SUBJECT: COMANCHE PEAK NUCLEAR POWER PLANT, UNITS 3 AND 4
DOCKET NUMBERS 52-034 AND 52-035
RESPONSE TO REQUEST FOR ADDITIONAL INFORMATION NO. 4725

RESPONSE TO REQUEST FOR ADDITIONAL INFORMATION

Comanche Peak, Units 3 and 4

RAI NO.: 4725 (CP RAI #168)

Figure 1: Location of Alpine earthquake (Sources in Legend).

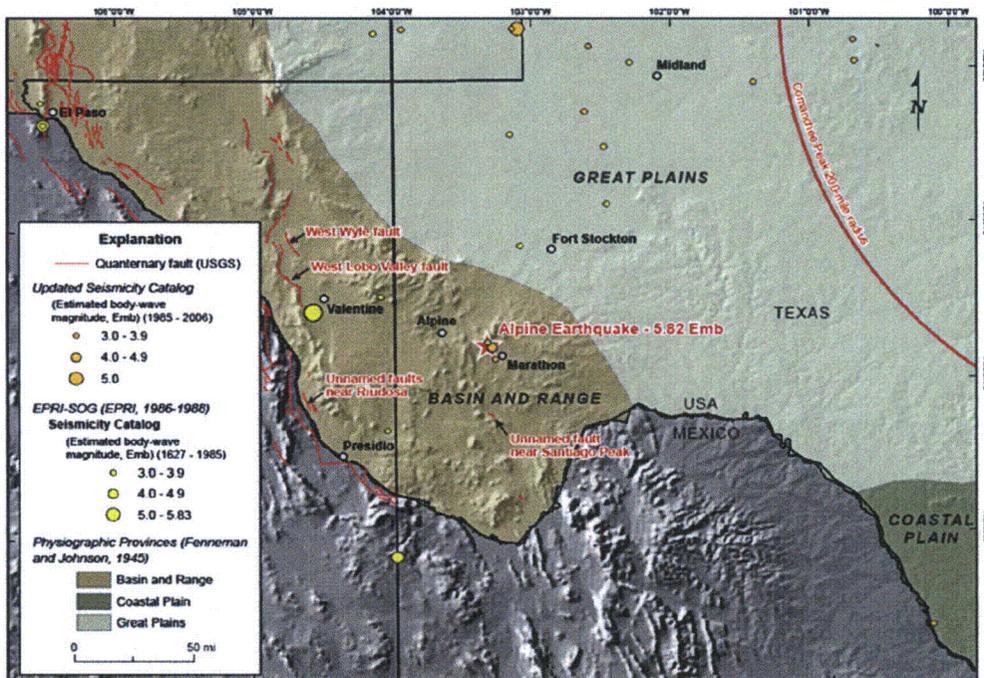
In response to RAI 2.5.2-4 (ML092820486), you stated that "1) the EPRI-SOG model does not adequately describe the Alpine earthquake and 2) it is not legitimate technical interpretation of the earthquake to account for its occurrence by updating the Mmax values of the contributing EPRI-SOG source zones that contain the earthquake." You stated that you reached this conclusion by using your expert judgment and based on input you received from Dr. Diane Doser, and subsequently you created a new seismic source model to incorporate the potential contributions of such similar future earthquakes in your hazard estimations. You have not conducted a Senior Seismic Hazard Analysis Committee (SSHAC) study for the development of your new seismic source. The staff examined the e-mail correspondence between you and Dr. Doser at the site audit conducted on April 7-8, 2010, and found that even though she believes this earthquake is a result of the tectonic forces related to the Rio Grande Rift system, she clearly indicated that the scientific work on this earthquake is quite limited and uncertainties exist. Given the uncertainty surrounding the tectonic causes of this earthquake, the staff is concerned that your model does not adequately represent the potential hazard at the site. Because this event is within the area of the several EPRI-SOG source models that host the CPNPP site and all of these sources have Mmax values lower than the observed earthquake, and based on the criteria in NUREG-0800, Standard Review Plan, Chapter 2.5.2, "Vibratory Ground Motion," and Regulatory Guide (RG) 1.208, "A Performance-Based Approach to Define the Site-Specific Earthquake Ground Motion", please update these models, similar to what you did in many of the other EPRI sources you used in your hazard calculations (FSAR Table 2.5.2-210). The updated analysis should incorporate the impacts of the Mmax updates to the EPRI-SOG sources based on the occurrence of this magnitude 5.8 earthquake. Also, please evaluate if any of the unused seismic sources should now be used because their seismic source model parameters need to be updated due to the occurrence of this earthquake (i.e., will this update bring the unused seismic sources' hazard contributions above the 1% threshold?)

The 14 April 1995, Emb 5.7 Alpine earthquake was felt over an area of approximately 760,000 km² and had a maximum intensity of MMI VI (Frohlich and Davis, 2002). Figure 1 shows the general setting of the 1995 Alpine earthquake in relation to physiographic provinces (Fenneman and Johnson, 1946) and the terrain of western Texas, faults from the USGS Quaternary fault and fold database (USGS, 2006), and historical earthquakes (FSAR Subsection 2.5.2.1). The CMT focal mechanism for the Alpine earthquake indicates normal slip on moderately dipping nodal planes (Global CMT Project, 2007). It is the second largest earthquake recorded in Texas (the 1931 Valentine earthquake was Emb 5.8). Many small landslides were triggered in the mountains surrounding the epicentral region (Frohlich and Davis, 2002), but no fault-related surface deformation has been identified. Also, the earthquake has not been associated with a causative fault.

Figure 2.5.2-259 Logic Tree of Return Period and Characteristic Magnitude for the Meers Fault

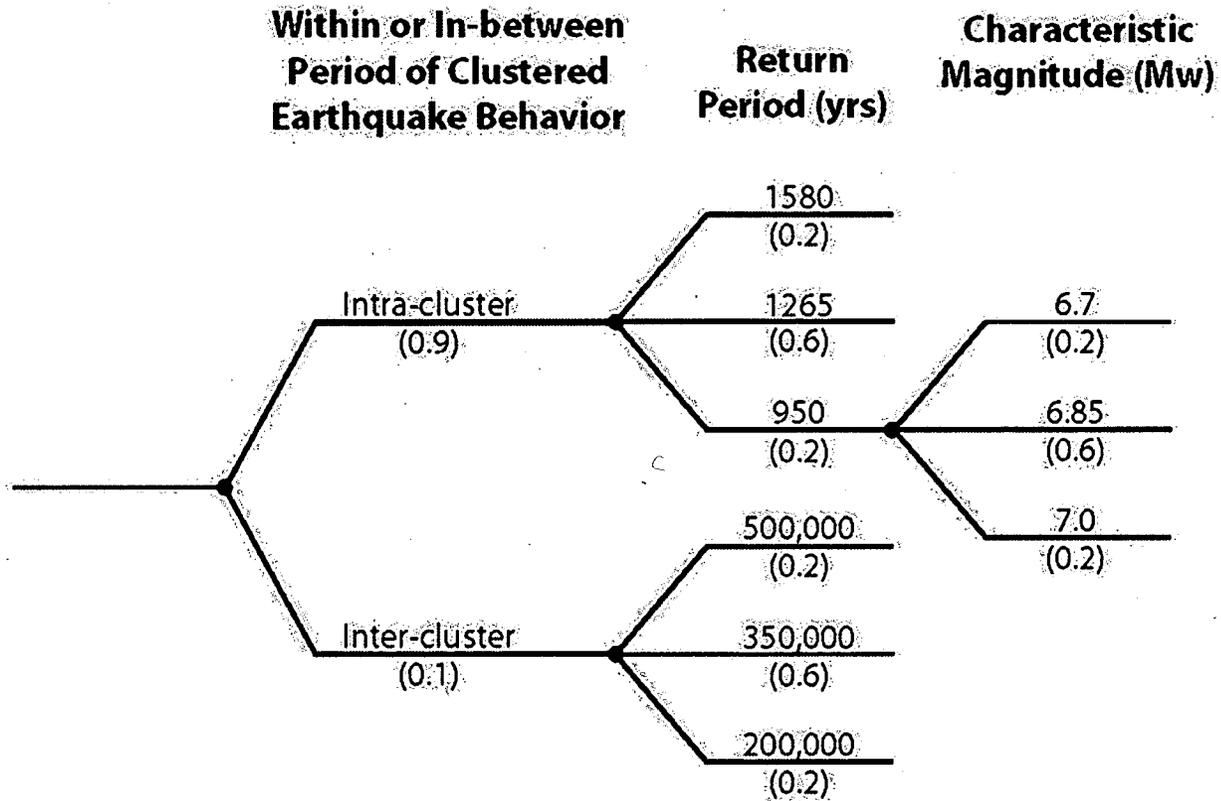
The Meers fault logic tree presented in response to RAI 11 Question 02.05.02-5 has been included in the FSAR as Figure 2.5.2-259. Several FSAR subsections have been modified to support this logic tree.

The final characteristic magnitude distribution used for the Meers fault is: Mw 6.7 (m_b 6.7), Mw 6.85 (m_b 6.82), and Mw 7.0 (m_b 6.9) with weights 0.2, 0.6, and 0.2, respectively (Figure 2.5.2-259). Mw 6.7 (m_b 6.7) is chosen as the lower bound instead of Mw 6.6 (m_b 6.7) because it is not considered likely that only the 26 km of the Meers fault scarp is related to the Holocene ruptures. Mw 7.0 (m_b 6.9) is chosen as the maximum bound because it is the maximum estimated magnitude of any regression and it is roughly equivalent to other estimates of characteristic

Epistemic uncertainty in return periods for characteristic earthquakes on the Meers fault is implemented through return period branches on a logic tree (Figure 2.5.2-259). The data presented by Swan, et al. (Reference 2.5-389) on the timing of Meers earthquakes suggests that there have been two Holocene events preceded by a long period (greater than 200,000 years) of inactivity, indicating that the Meers fault exhibits clustered earthquake behavior. The initial branch of the logic tree represents uncertainty in whether or not the Meers fault is in an earthquake cluster.

The most probable minimum and maximum return periods are both given equal weight of 0.2 in the logic tree for the return period of intra-cluster events. The remaining 0.6 weight is given to the median of the most-probable minimum and maximum return periods (1265 years) (Figure 2.5.2-259). This weighting reflects the belief that it is most likely for the intra-cluster return period to be somewhere between the minimum and maximum bounds.
